Technical Memorandum

To	Brad Cabell	Contact No.	s 9(2)(a)
Copy to		Email	brad.cabell@nzta.govt.nz
From	s 9(2)(a)	Project No.	12560966
Project Name	Queenstown Alliance SH6 / SH6A design review		
Subject	Review of the proposed design and modelling assessments completed for the SH6 / SH6A intersection, Frankton / Queenstown

Figure 1 Extract of Figure 12 from SH6 Frankton Eastern Corridor Operation and Future Performance (dated April 2022)

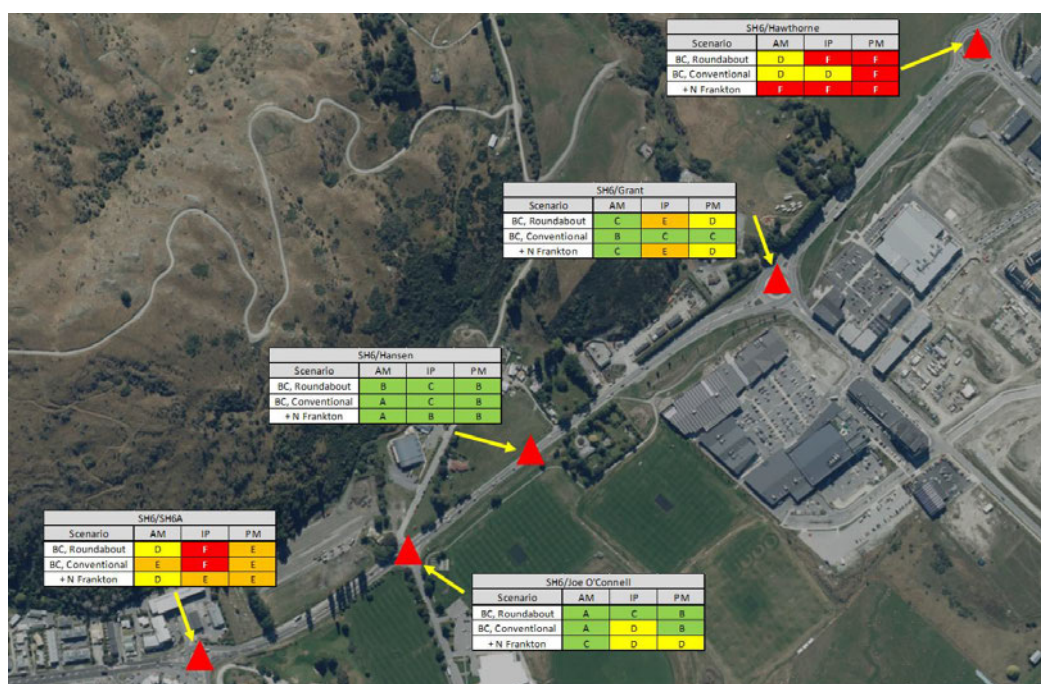
With reference to the memorandum titled *SH6 Frankton Eastern Corridor Operation and Future Performance* (dated April 2022), the corridor and intersection modelling was updated to include 50% build-out of the Frankton North development. It was identified that the travel times improved on the SH6 corridor due to the traffic pattern changes from the increased land use on Frankton North, and the delivery of LOS D performance at the intersection is potentially at a level higher than could be expected in the network (LOS E would seem an appropriate target).

Additionally, the Paramics model identified the overall intersection LOS improved at the SH6 / SH6A intersection with Frankton North, when compared against the previous analysis completed for the Business Case. It was stated that the operation of this intersection did not deteriorate significantly due to wider uptake in public transport use (15% PT), and other traffic distribution effects.

On this basis, there may be the potential to streamline the proposed intersection design, as the modelling outputs are indicating the intersection has not reached capacity, and that demands will be reduced with the development of Frankton North.
